Access Compliance Report

Public Rights-of-Way

(Curb Ramps)

Intersection ID: 49255	Main Street: HOPKINS_ST	Cross Street: OAKBURN_DR	Location: SW
ADA ID: EFE96824ACD7	Ramp Type: PerpDiag	Initial Pass/Fail: Fail	Overall Compliance: No
Severity Score: 8.75			
Codes/Mitigation Info/Possible Solution		Field Measurements/Component Compliance

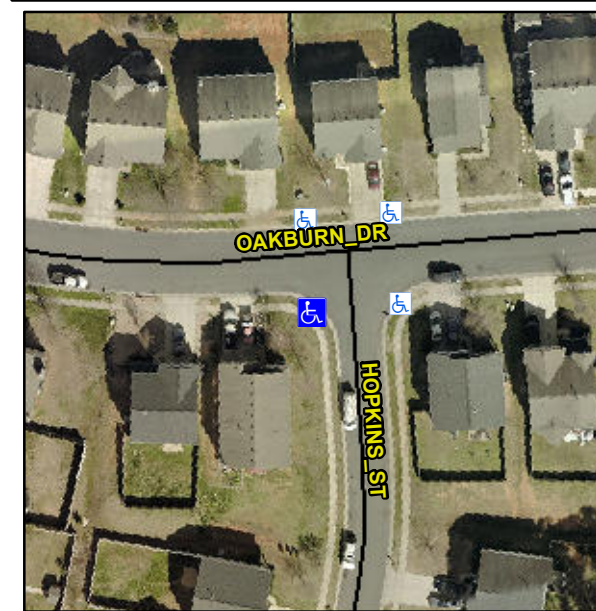
Not Found, R304.5.1

Compliance	Description	Data	Compliance	Description	Data
N/A	Ramp Length (in)	47.0	Yes	Ramp Slope (%)	6.6
No	Ramp Width (in)	42.5	Yes	Ramp XSlope (%)	1.9
N/A	Flare Type LT	N/A	N/A	Flare Type RT	N/A
N/A	Flare Slope LT (%)	N/A	N/A	Flare Slope RT (%)	N/A
N/A	Flare Traversable LT?	N/A	N/A	Flare Traversable RT?	N/A
N/A	Landing Length (in)	N/A	N/A	DWS Provided?	N/A
N/A	Landing Width (in)	N/A	N/A	DWS Contrast?	N/A
N/A	Landing Slope (%)	N/A	N/A	DWS Length (in)	N/A
N/A	Landing X Slope (%)	N/A	N/A	DWS Full Width?	N/A
N/A	Landing Curb? (Y/N)	N/A	N/A	DWS Offset (in)	N/A
N/A	Shared Landing?	N/A			
N/A	Gutter Ponding?	N/A	N/A	Gutter Slope (%)	N/A
N/A	Gutter Lip Ht (in)	N/A	N/A	Gutter X Slope (%)	N/A
N/A	Painted X Walk1?	No	N/A	Painted X Walk2?	No
	X Walk 1 Direction	To E		X Walk 2 Direction	To N
N/A	X Walk 1 Width (in)	N/A	N/A	X Walk 2 Width (in)	N/A
	X Walk 1 Slope (%)	0.8		X Walk 2 Slope (%)	1.4
	X Walk 1 X Slope (%)	4.4		X Walk 2 X Slope (%)	0.3

Remove & Replace Curb Ramp With Two New Directional Ramps or Equivalent.
